SUBJECT: **DEMONSTRATION / DELIVERY HOLD - Safety Recall 13S04 – Supplement #2**
Certain 2013 Model Year Explorer, Taurus, MKS, Flex, MKT, Fusion, MKZ, and Police
Interceptor Utility and Sedan Vehicles
Fuel Delivery Module Replacement

DEMONSTRATION / DELIVERY HOLD - 13S04 Supplement #2

Certain 2013 Model Year Explorer, Taurus, MKS, Flex, MKT, Fusion, MKZ, and Police Interceptor Utility and Sedan Vehicles - Fuel Delivery Module Replacement

FIGURE 1

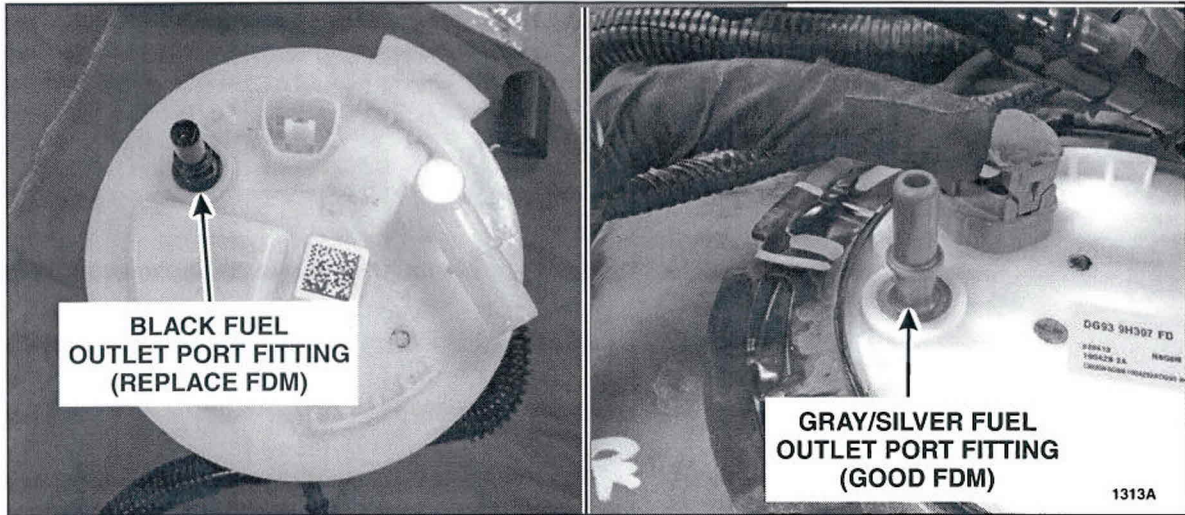
3. Remove the fuel tank. For additional information, refer to WSM Section 310-01.
4. Inspect the color of the fuel outlet port fitting on top of the FDM. See Figure 1.
 - If the color of the fuel outlet port fitting is black, replace the FDM. For additional information, refer to WSM Section 310-01.
 - If the color of the fuel outlet port fitting is gray/silver, no further action is necessary. Reinstall the fuel tank. For additional information, refer to WSM Section 310-01.
